Project	<b>IEEE 802.16 Broadband Wireless Access Working Group</b> < <a href="http://ieee802.org/16">http://ieee802.org/16</a> >	
Title	<b>Clarification on STC Data Mapping for Optional Zones</b>	
Date Submitted	<b>2005-03-16</b>	
Source(s)	<p>Wonil Roh, JeongTae Oh, Kyunbyoung Ko, Chan-Byoung Chae, Hongsil Jeong, Sung-Ryul Yun, Seungjoo Maeng, Jaeho Jeon, Jaeyeol Kim, Jaehee Cho, Soonyoung Yoon, Yong Chang</p> <p><b>Samsung Electronics Co., Ltd.</b></p> <p>David Garrett, Erik Lindskog, Kamlesh Rath, Aditya Agrawal</p> <p><b>Beceem Communications, Inc.</b></p> <p>Wen Tong, Ming Jia, Hua Xu, Dongsheng Yu, Jianglei, Ma, Peiyong Zhu, Mo-Han Fong, Hang, Zhang and Brian Johnson</p> <p><b>Nortel Networks</b></p> <p>Nageen Himayat, Sumeet Sandhu, Qinghua Li, Jose Puthenkulam, Randall Schwartz</p> <p><b>Intel</b></p>	<p><a href="mailto:wonil.roh@samsung.com">wonil.roh@samsung.com</a> Voice: +82-31-279-3868</p> <p><a href="mailto:dgarrett@beceem.com">dgarrett@beceem.com</a></p> <p><a href="mailto:wentong@nortelnetworks.com">wentong@nortelnetworks.com</a></p> <p><a href="mailto:nageen.himayat@intel.com">nageen.himayat@intel.com</a></p>

## Clarification on STC Data Mapping for Optional Zones

**Figure 2511 — Uplink data mapping for 2-antenna SS with matrix A for the optional PUSC permutation**

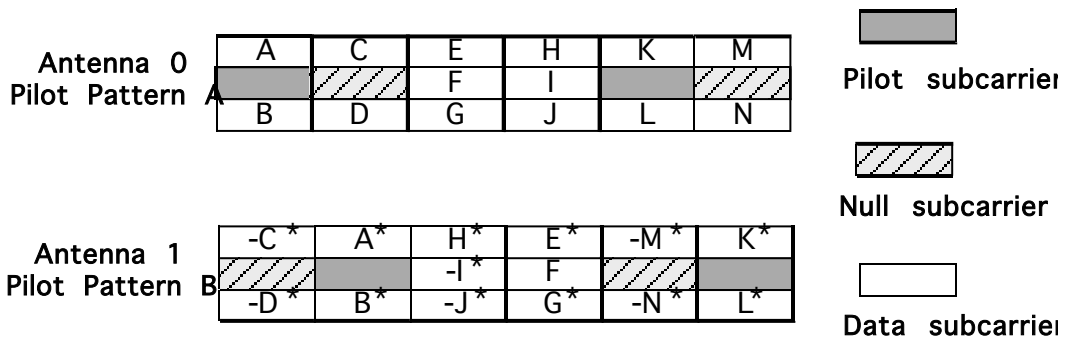
For the optional PUSC permutation with matrix A in 8.4.8.3.3, the data subchannels shall be allocated for two consecutive slots in time. As can be seen in Figure 251l, STC encoded data symbols shall be time mapped over two OFDMA symbols. The mapping starts at the lowest numbered subcarriers of lowest slot and continues in an ascending manner in subchannels first and then proceeds to the next two symbols in time.
